CARLSBAD SEAWATER DESALINATION PROJECT

FLOW, ENTRAINMENT AND IMPINGEMENT MINIMIZATION PLAN

**ATTACHMENT 10 – EXPLANATION OF MODIFICATION TO
ENTRAINMENT MINIMIZATION TECHNOLOGY MEASURES**

March 27, 2009

Figure 4-8. Microscreens in filtration and backwash flow modes

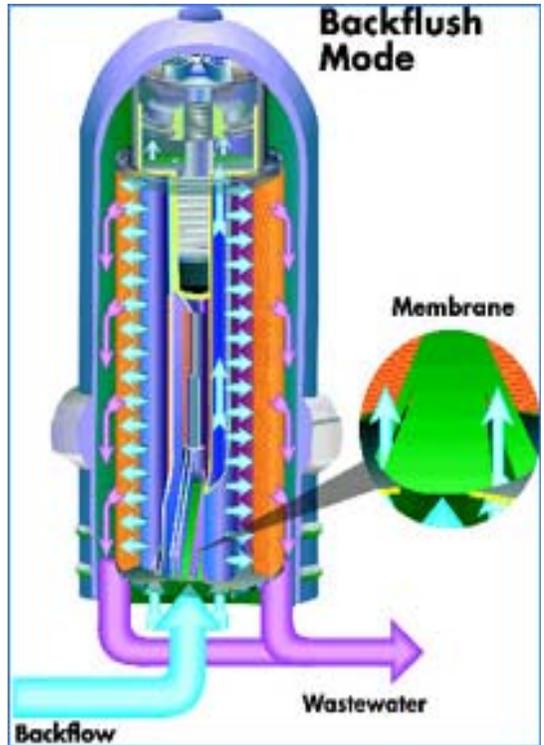
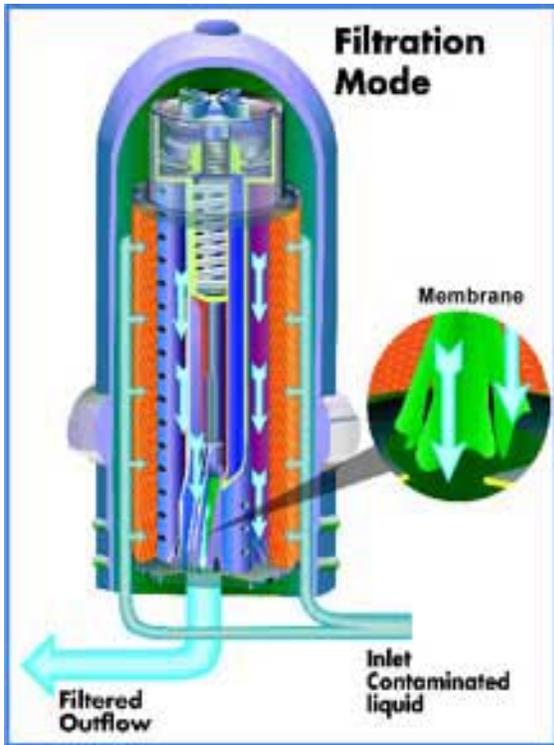
Therefore, Poseidon determined that these technology measures would not be effective in the minimization or reduction of entrainment, and the decision was made to remove these technology measures from the Plan.

EXHIBIT A
ELIMINATED DESCRIPTION OF REMOVED TECHNOLOGY MEASURES

4.4.2 Installation of Micro-screens Ahead of Seawater Pretreatment Facilities

Figure 4-9 – Ultrafiltration Pretreatment System

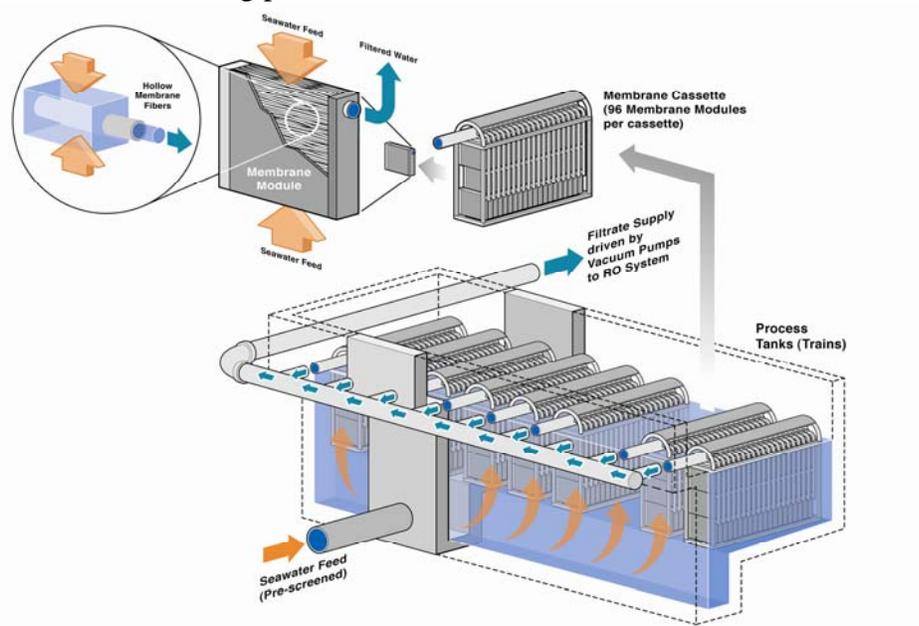
1.2.1 Use of Low Pressure Membrane Pretreatment System

Figure 4-10 – Algae Removed by the UF Pretreatment System

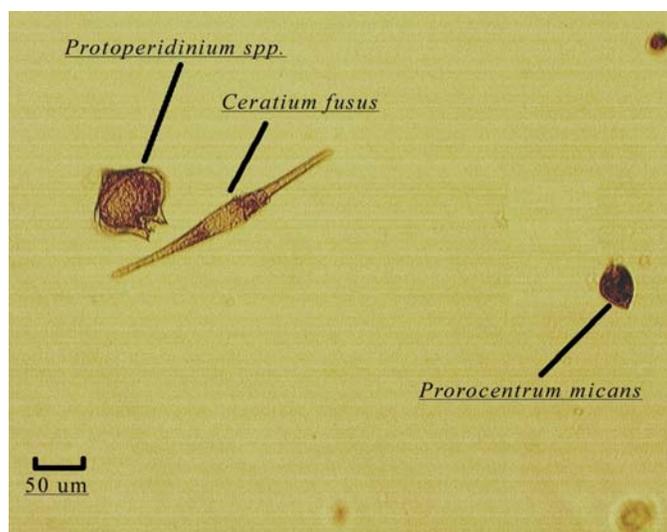
In the case of Poseidon's proposed screening and pretreatment technology measures, the Commission found that the entrained organisms will be subject to a number of stressors – including high pressures, significant changes in salinity, possible high temperature differences if the power plant is operating, etc. – and they will then be discharged to a different environment than is found in Agua Hedionda.⁵ From this, the Commission concluded that any one or a combination of these stressors could result in mortality of the marine organisms prior to the return to the ocean.⁶
